Construction Verification Audit Report

Shoal Bay Waste Disposal Facility, Stage 3 and 4 - Landfill Cap

Approval Holder: City of Darwin
EPA Approval No.: EPA321-02

20 March 2024

Figure 4-2 Typical Detail for Stage 3 Northern and Eastern Batter Edge (toe) (Golder Associates, D013, 2021)

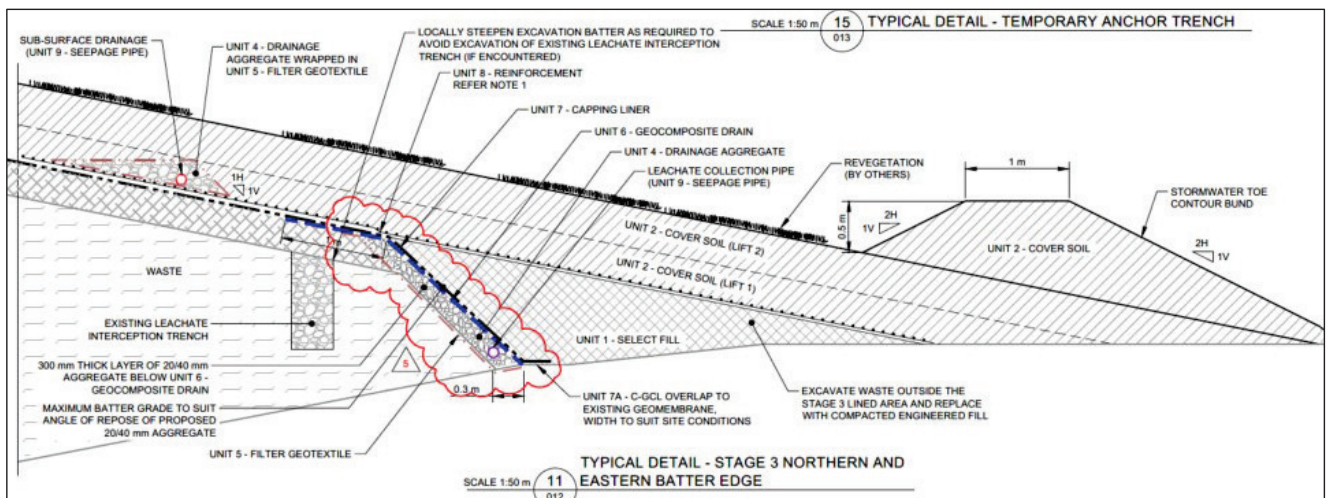
Drawing 020 - Reinforcement at Corners Typical Sections and details	As above	Y	
Design Variations and Non Conformances			
DV02a - Drawing 13, Detail 11. Movement of northern and eastern batter edge. Addition of aggregate below Unit 6. Steepening of batter where required	Appendix E (73852-1-SV-AS02-r4 (Pipe), 16/11/2022)	Y	
DV06 - Coated GCL Anchor trench along cap ridge/corner to allow panels to be orientated perpendicular to the slope	CQA Report - Section 4.2.2, Appendix H (As-built) and Appendix K (Daily Site Visit Reports)	Y	
DV09 - Revised Type B and D anchor trench dimensions. Use of Cement Stabilised sand as backfill to anchor trenches. Reduced tensile strength of Type D reinforcing geogrid	CQA Report - Section 3.4.3.1 and Memo 21453643-039-M-Rev0 (in Appendix D)	Y	
DV11 - Proposal of material that is non conforming for % passing 0.075mm sieve and change in thickness of Unit 29 layer to at least 25mm (rather than 300mm) and relocated to be between Type D Geogrid and Type B Reinforcement Geotextile	CQA Report - Section 3.8.2 and Memo: 21453643-058-M-Rev0 (Appendix D)	Y

DV02a	Minor	Amendment to Stage 3 Butler Tote Detail	Drawing 011, Detail 11. Movement of northern and eastern letter edge. Addition of aggregate below unit 6. Steepering of letter where required	Memo: 21403843-002-M-Rev1	Letter dated 4 October 2021	Council has submitted to EPA	Increased risk of leachate infiltration between GCL and soil liner (geomembrane) leading to leachate escape at toe of landfill	Not likely	Minor	Low	The design has improved the capacity of the secondary leachate drain to capture any leachate moving past the existing leachate trench, as the aggregate drainage layer is now sitting on the downslope portion of the cell liner, rather than on the crest. The design change was also necessary due to the shorter length of existing liner available for overlap by the GCL at the crest of the base liner.
DV02b	Minor	Amendment to Unit 1 Testing Frequency at Toe Burd	Field Density testing of Unit 1 - Select Fill placed to form the toe band on the N and E toe of Stage 3 changed from that is 7.3.2.2 to 7.3.2.4 - 1 test per every second layer per 50m of length	Memo: 21403843-004-M-Rev0	Letter dated 4 October 2021	Council has submitted to EPA	Inadequate compaction of Unit 1 material at Toe Burd, leading to leachate management issues at toe and instability	Rare	Minor	Low	The reduced testing density will still provide sufficient evidence that compaction has been achieved of the Unit 1 material at the toe of the landfill cap

SCALE AT A3:	DATE:	DRAWN:	CHECKED:
-	24/10/22	DD	DD
PROJECT NO:	DRAWING NO:	REVISION:	
P2007	A3/02	0

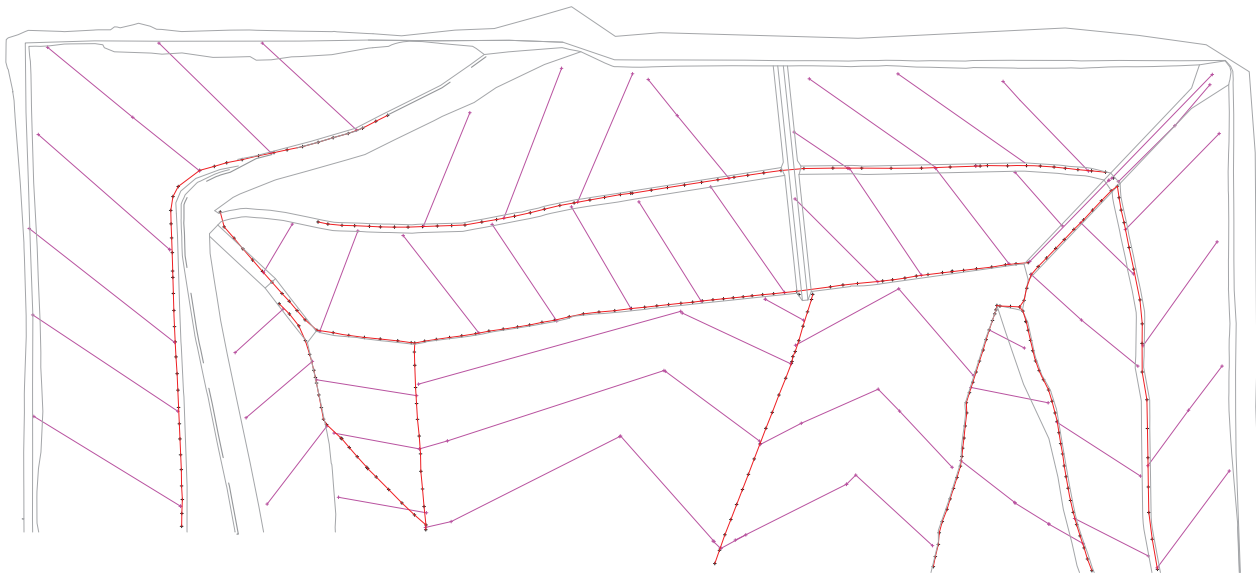
Drawings			
Drawing 007 - General Arrangement Plan - Passive Gas	Appendix E As built drawing A3/02	Y	Refer to DV18. The updated design involved 2 Passive Gas Vents south of the Stage 3 Pivot Irrigation Area. Construction of these were overseen by the GITA. The vents can be surveyed at any time post construction.
